RE: M2016-054 TR1 Adequacy Review 2

RE: Adequacy Review No. 2; Technical Revision (TR-1) – Revise Mining and Reclamation Plans and Maps to Account for Acreage Release Areas in AR-1; Irwin/Thomas Mine, Permit No. M-2016- 054

IRWIN/THOMAS MINE M2016-054 TECHNICAL REVISION 1
EXHIBIT C-5

**M2016-054 TECHNICAL REVISION 1
EXHIBIT C-4**

ATTACHMENT B
Boundary Exhibit Map

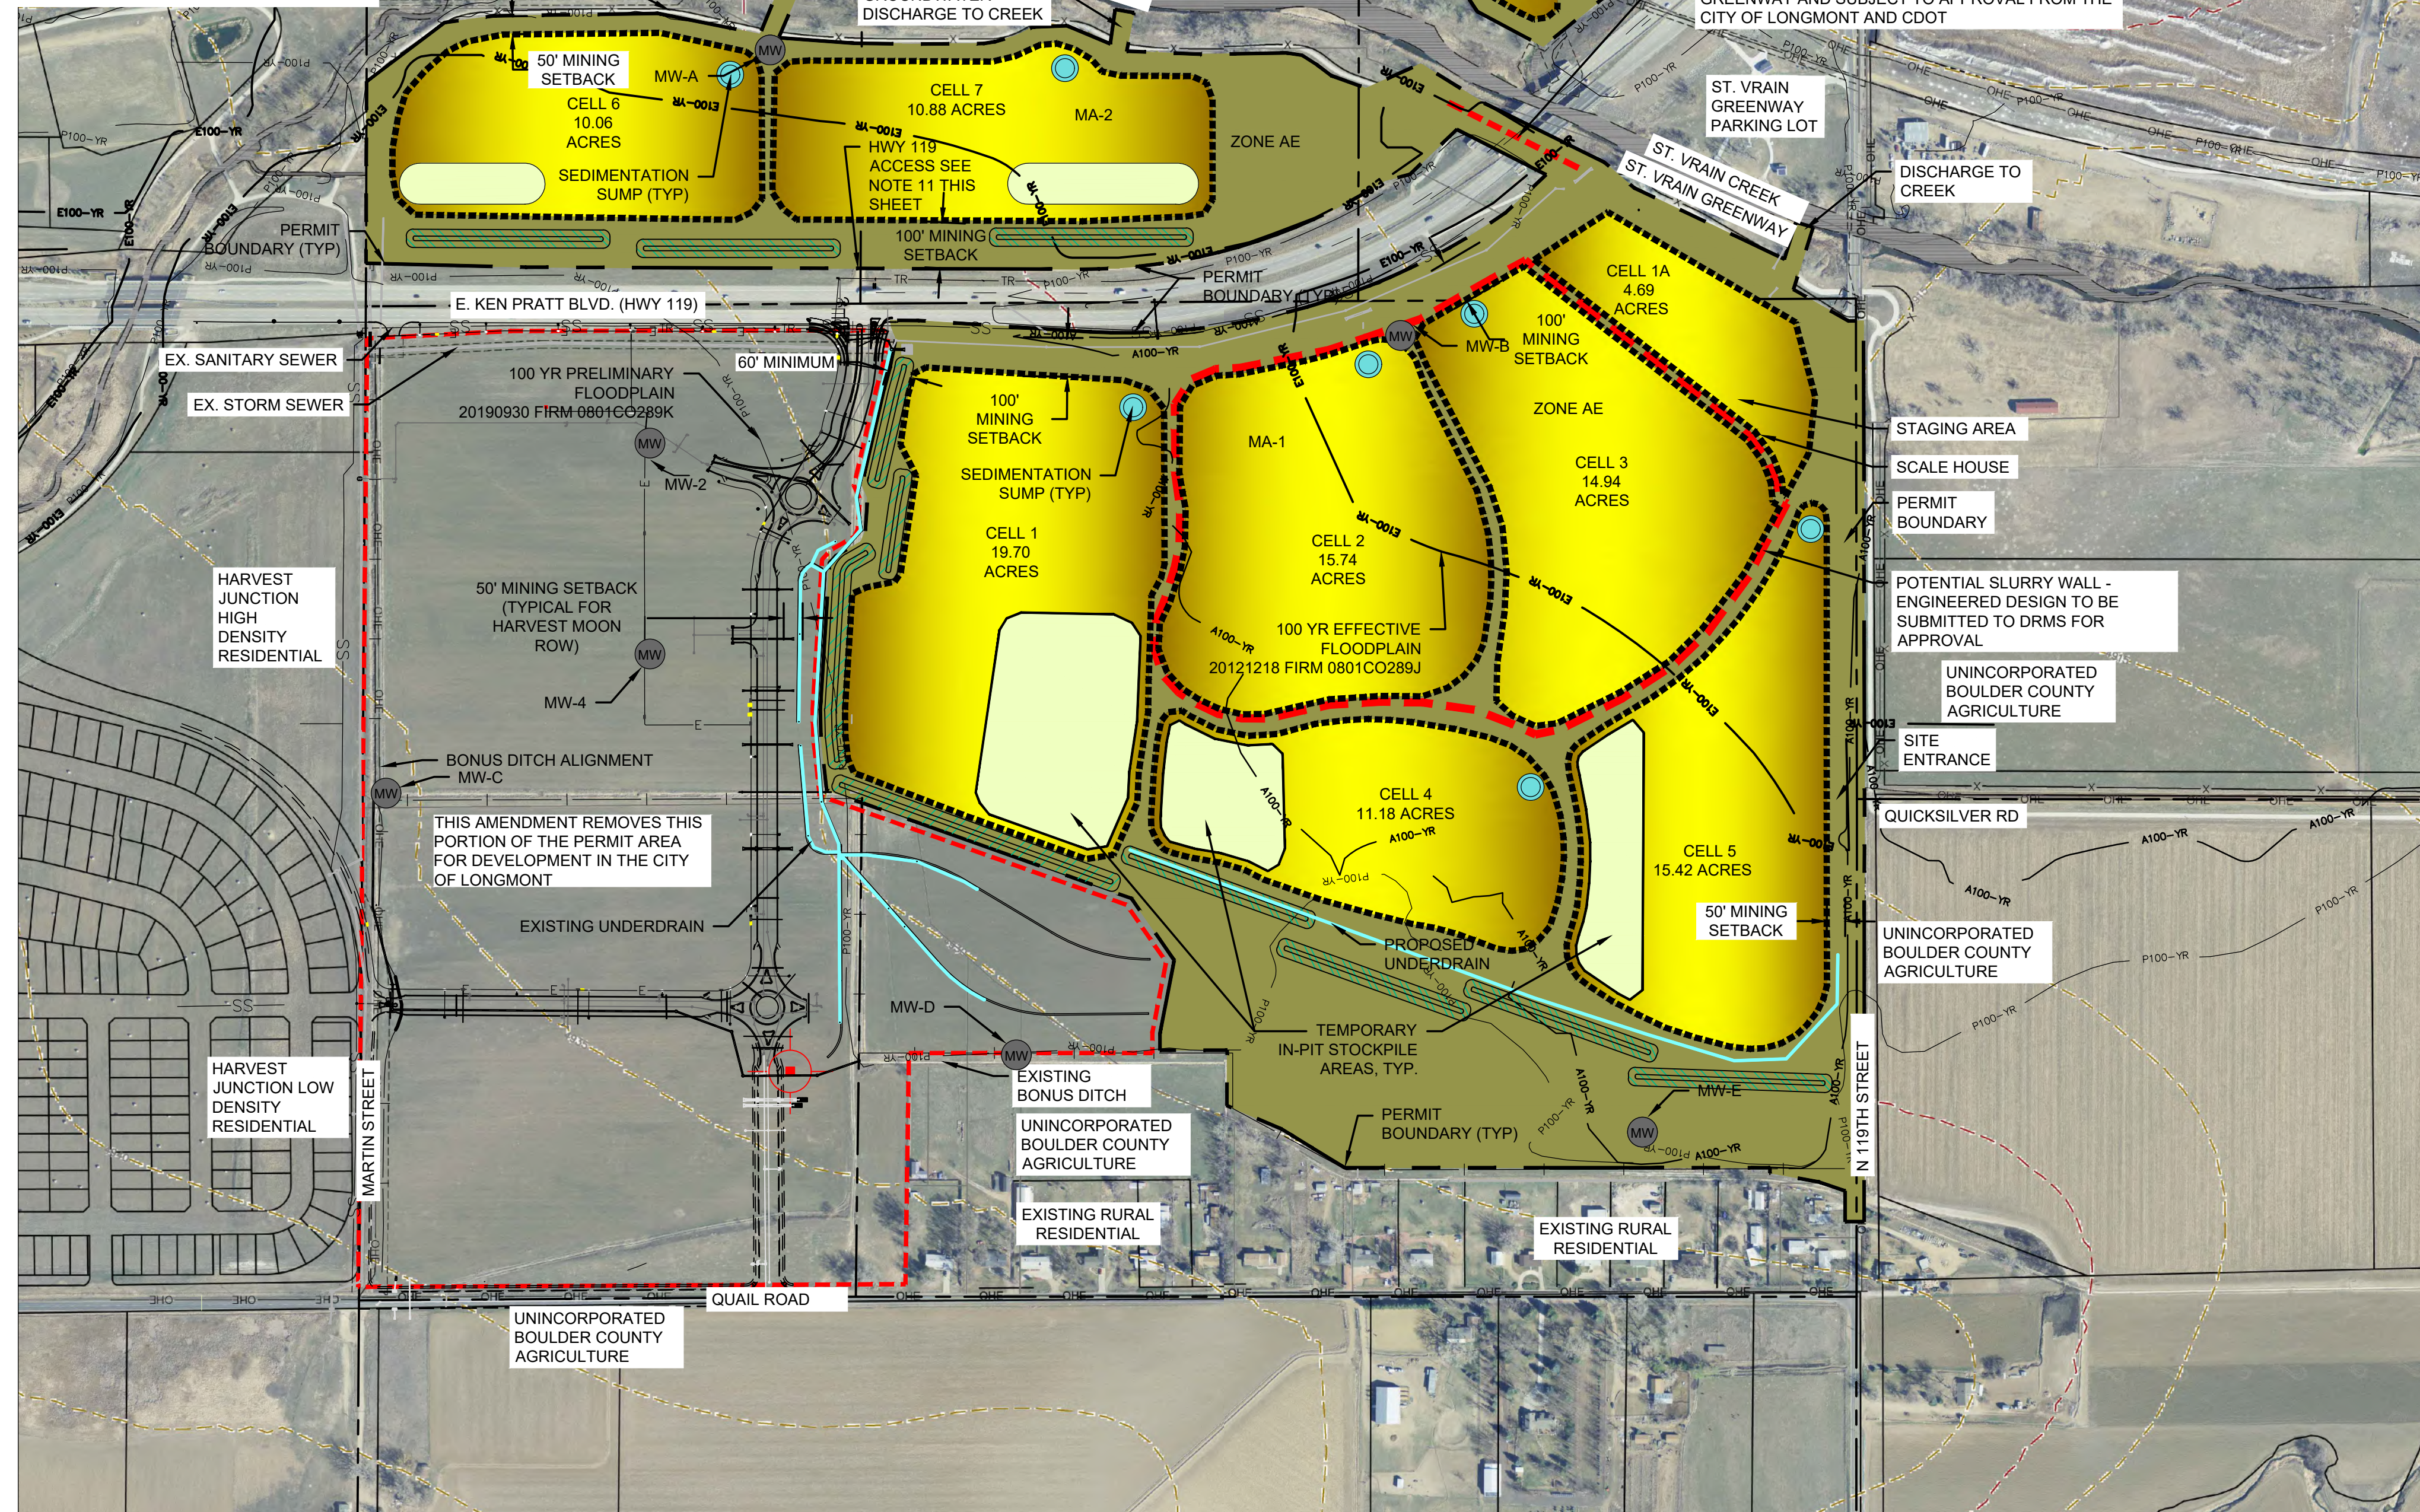
2. Please provide on a map the coordinates for all the permit boundary corners. The corners may be numbered on the map and a table provided listing the coordinates.

Applicant Response: The coordinates for the permit boundary are included as Attachment B, a Boundary Exhibit map. The Coordinates are numbered on the map and a table is provided listing the coordinates.

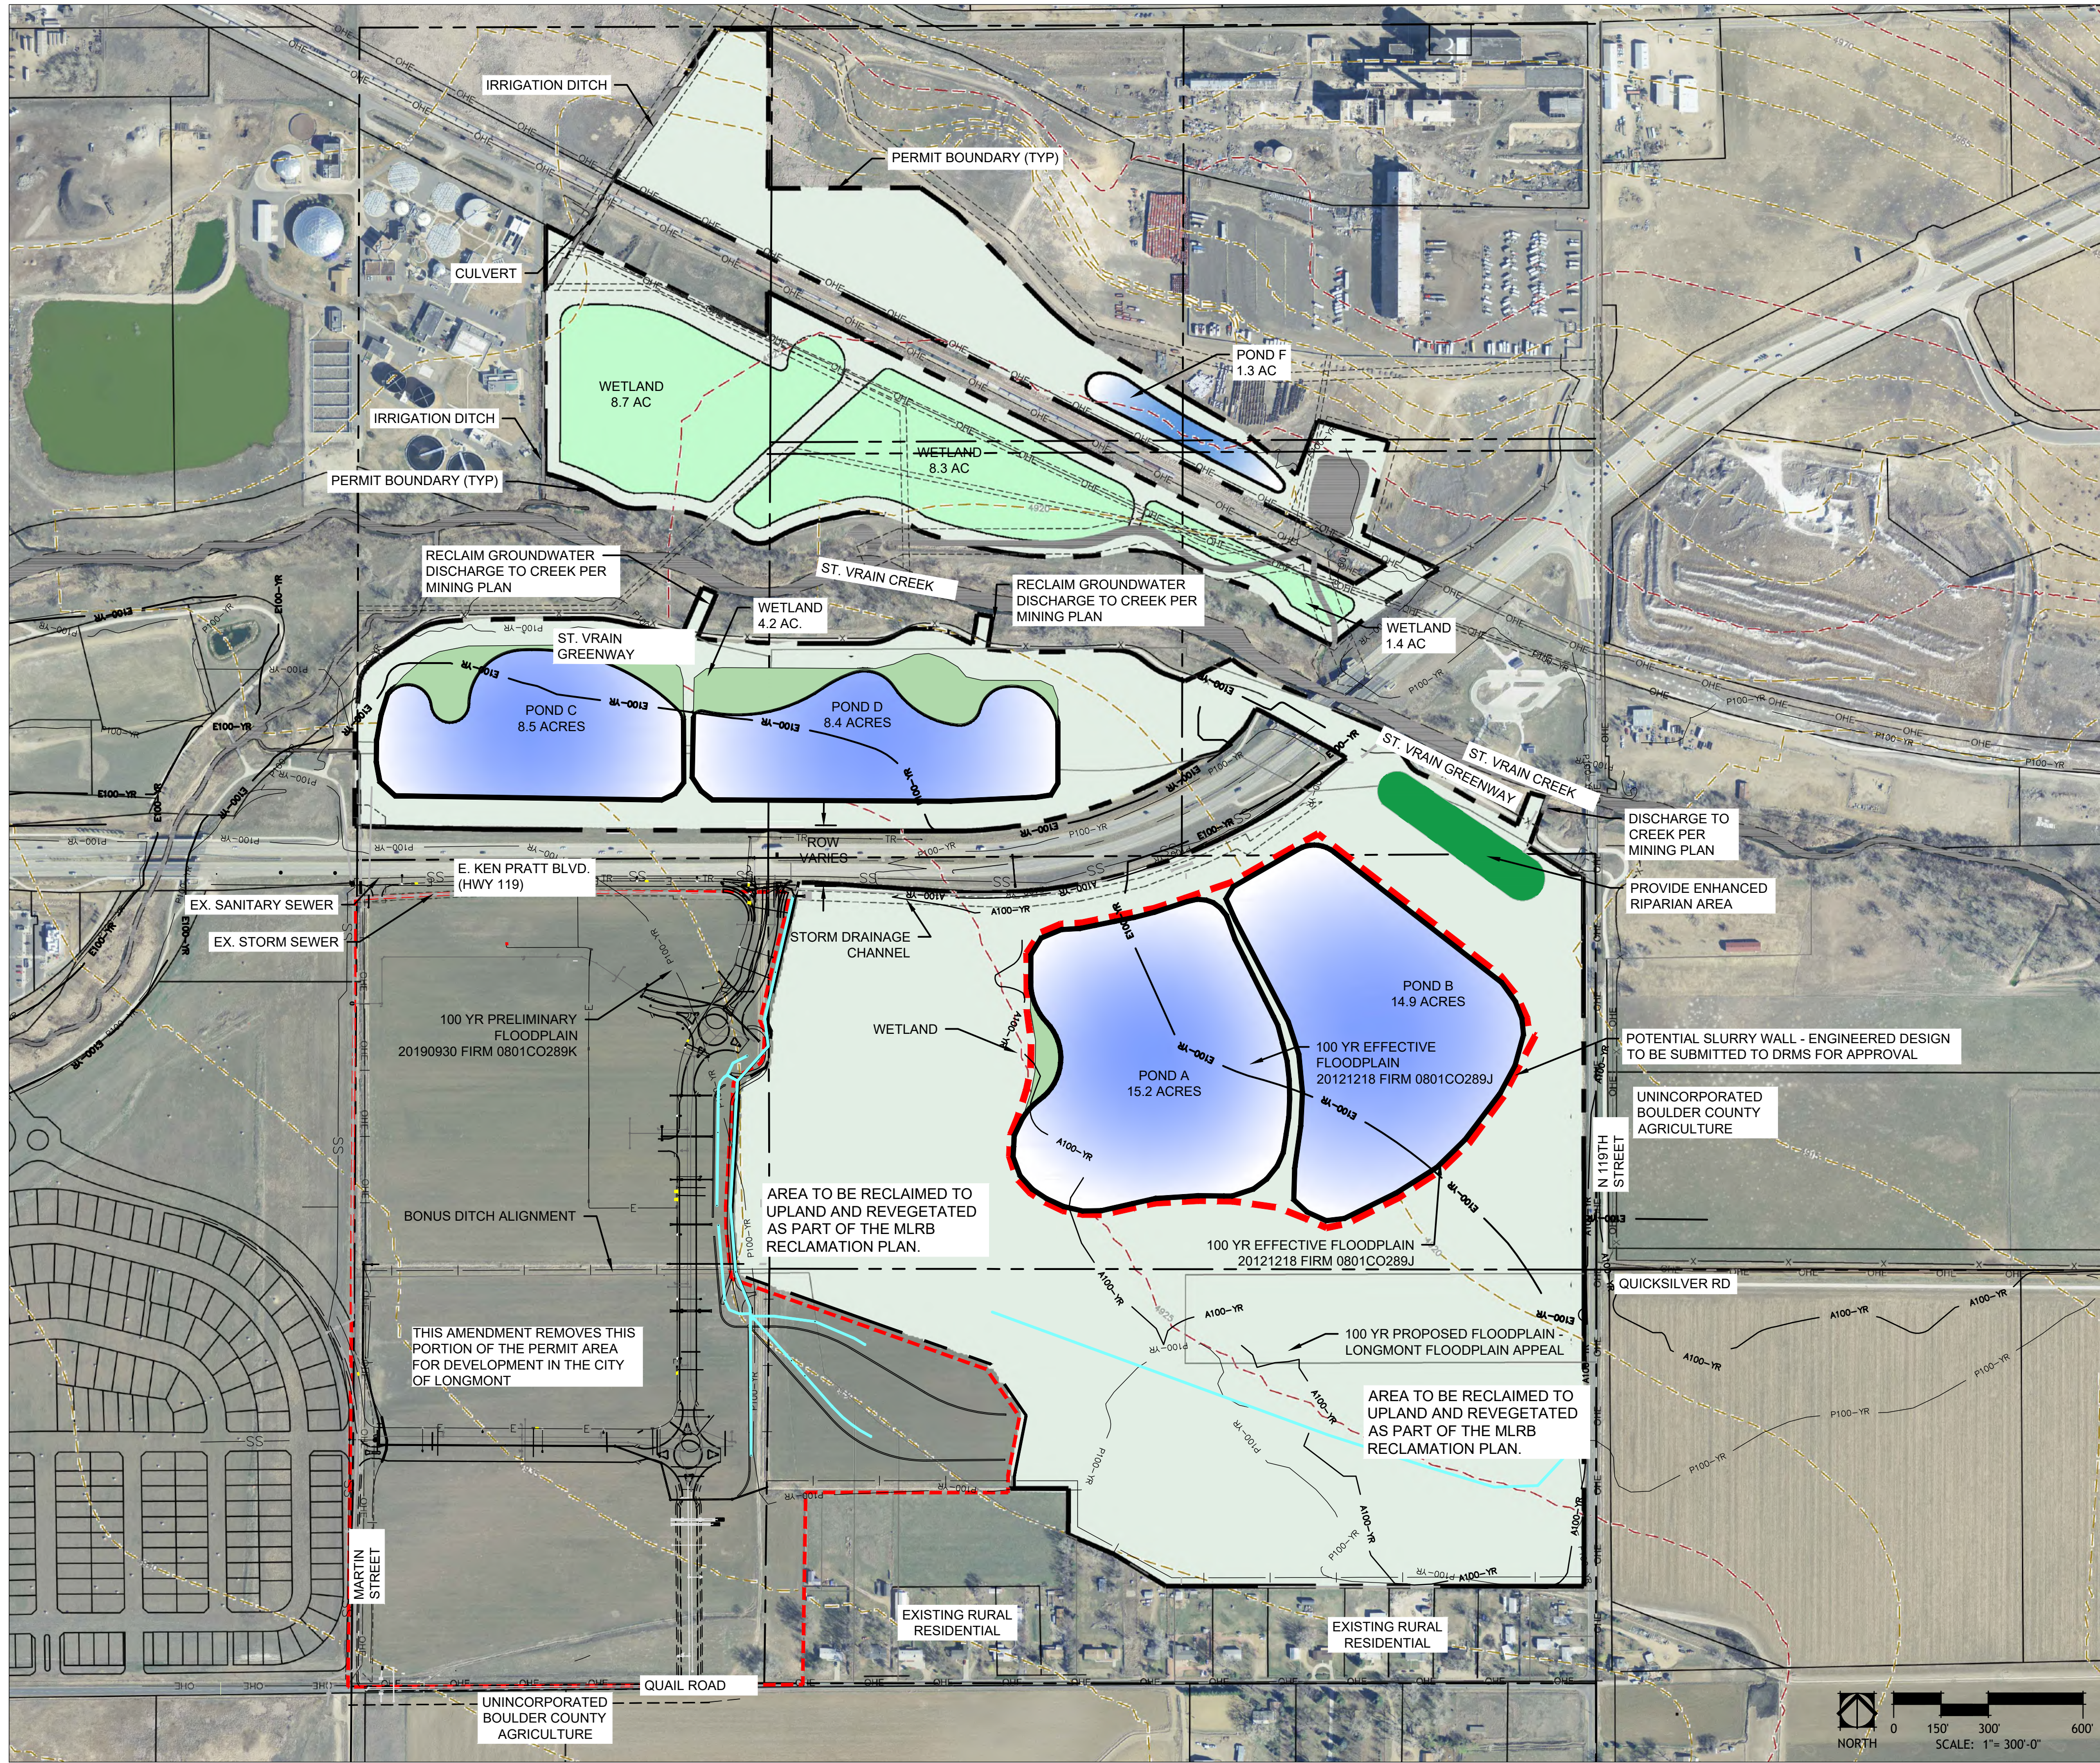
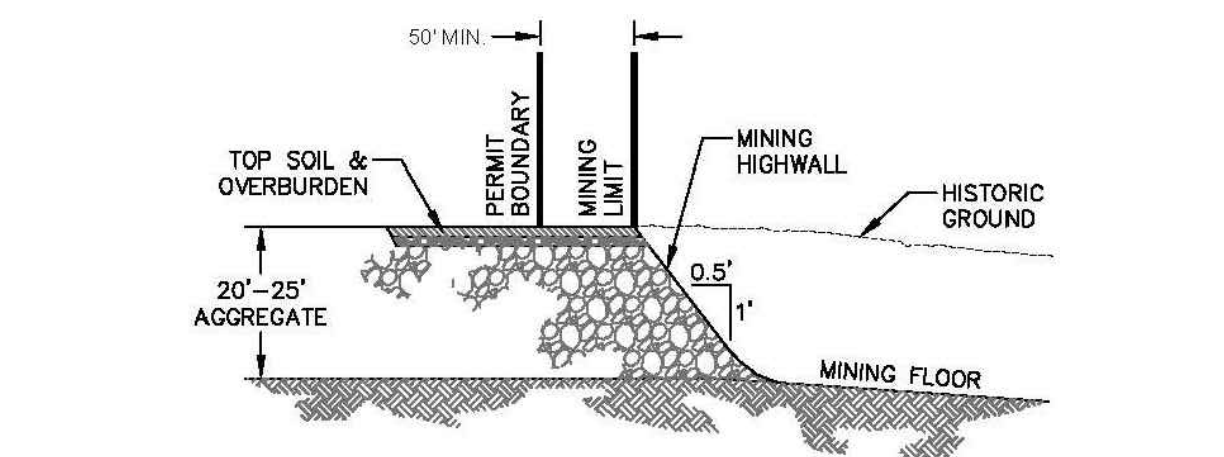
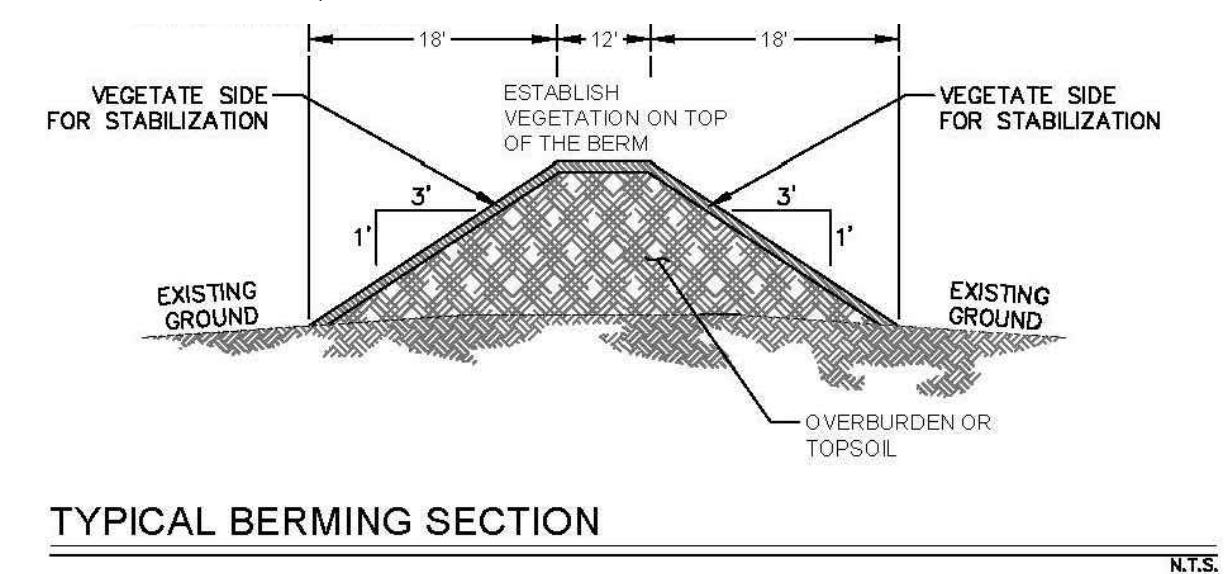
3. What order will the mine cells of MA-1 be mined? On map C-5 the mining sequence only notes that Cell 1A will be mined and backfilled prior to Cells 2 and 3.

4. Please clarify Note 2 on map C-5 that lists a permit area less than what the Division on file, 232.84 acres.

Applicant Response: Please note an updated Exhibit C4-Mining Plan Map is included as Attachment C. The cells will be mined in sequence following the numbered cells on the map. Prior to proceeding to Cell 6 (located north of HWY 119) , Holcim will submit a technical revision .

Applicant Response: The total land within the Permit boundary is 211.7 acres. This is also considered the area of disturbance. A table with the areas of each of the mining areas has been added to updated Exhibit C-4 – Mining Plan Map.

Revised EXHIBIT F - Reclamation Plan Map

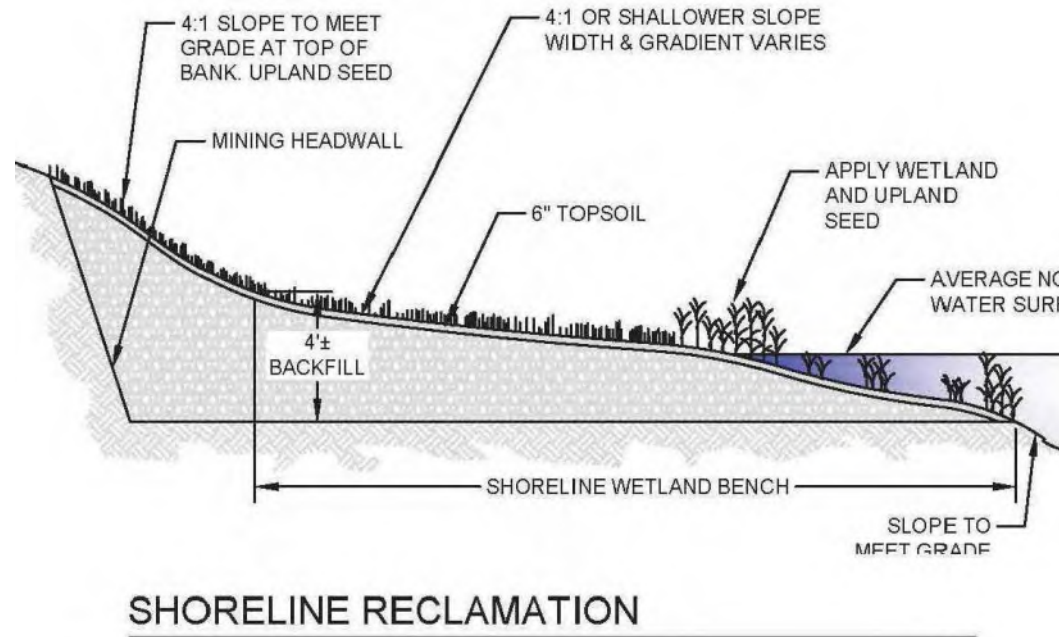
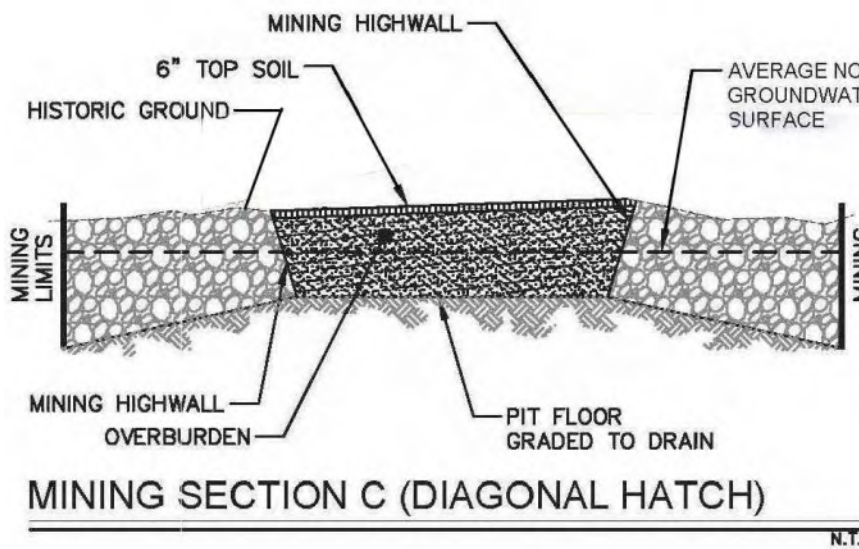
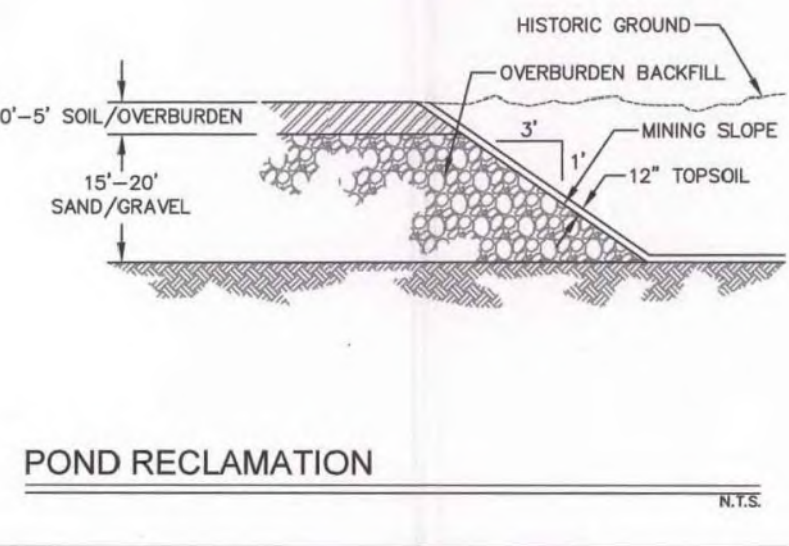
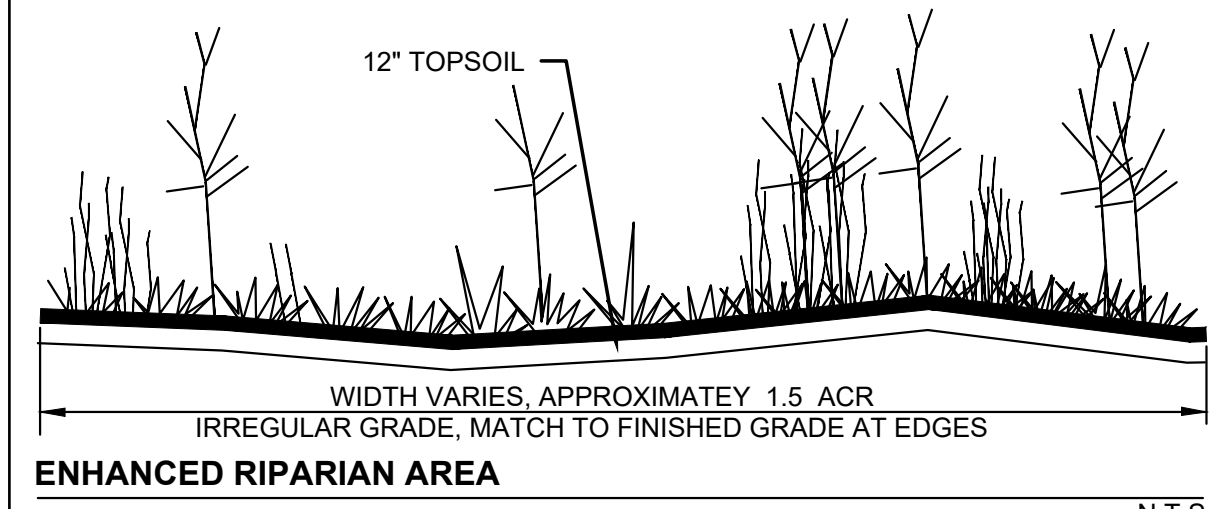
6. The Reclamation Plan Map needs to be updated to clearly reflect the installation of the perimeter underdrain along the southern portion of the MA-1 to mitigate the modeled groundwater mounding. The existing utility underdrains to the west of the side should also be reflected on this map.

Applicant Response: Exhibit F-Reclamation Plan Map has been updated to clearly reflect the installation of the perimeter underdrain along the southern portion of the MA-1 to mitigate the modeled groundwater mounding. The existing utility underdrains to the west of the side are also reflected on this map. The updated Exhibit F- Reclamation Plan Map is included as Attachment D.
